Location:	Brooklyn Basin (formerly known as “Oak to 9th Avenue”); specifically, Parcel C (APN 018 046501400).
Proposal:	Final Development Permit (FDP) for Parcel C, including 241 residential units and up to 3,500 sf ground-floor commercial space in an 81-foot tall building.
Applicant:	Zarsion America Inc., Erik Hayden (408)348-5679.
Owner:	ZOHP
Planning Permits Required:	FDP, compliance with CEQA.
General and Estuary Plan:	Planned Waterfront Development-1.
Zoning:	Planned Waterfront Zoning District (PWD-4)/D-OTN-4
Environmental Determination:	Final EIR certified on January 20, 2009
Historic Status:	Non-Historic Property
Service Delivery District:	3
City Council District:	2 – Abel Guillen
Action to be Taken:	Comment, only.
Finality of Decision:	NA.
For further information:	Contact case planner Catherine Payne at 510-238-6168 or by e-mail at cpayne@oaklandnet.com

CITY OF OAKLAND PLANNING COMMISSION

Case File: DA06011, PUD06010, PUD06010-PUDF05
Applicant: Erick Hayden
Address: Brooklyn Basin, Parcel C
Zone: D-OTN

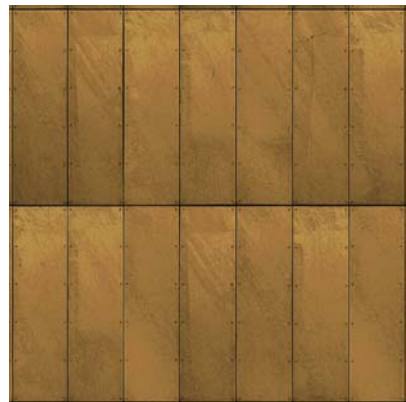
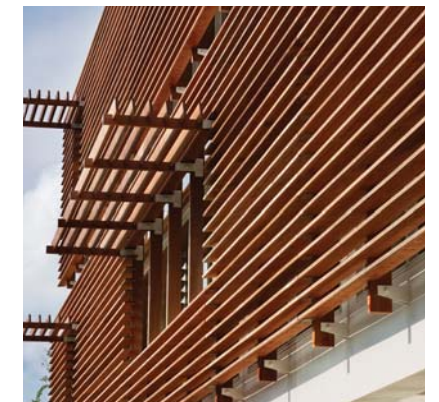
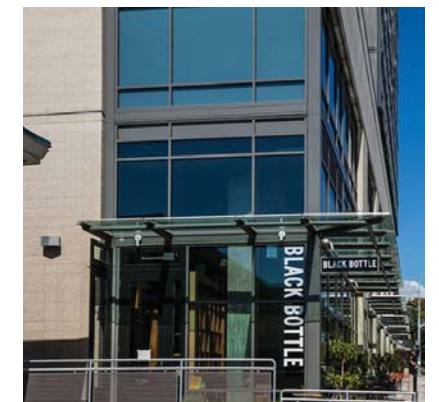
- **Materials:** The project includes a mix of materials, including cementitious treatments (plaster or stucco finish), and significant quantities of metal treatments. Staff believes that the metal finishes are critical to the architectural success of the building and seeks to ensure that the project retains the metal exterior treatment through to project delivery. Metal is a significantly more expensive finish than stucco. Applicants often seek to value-engineer exterior treatments during project delivery. Staff recommends that the DRC demand high-

quality finishes for this project, specifically retention of the metal finishes (and significant quantities thereof).

- Colors: Staff recommends that the applicant explore somewhat warmer options for the black metal panel and white cementitious products. The warmth of the custom patina metal should be complemented by the other dominant material colors.
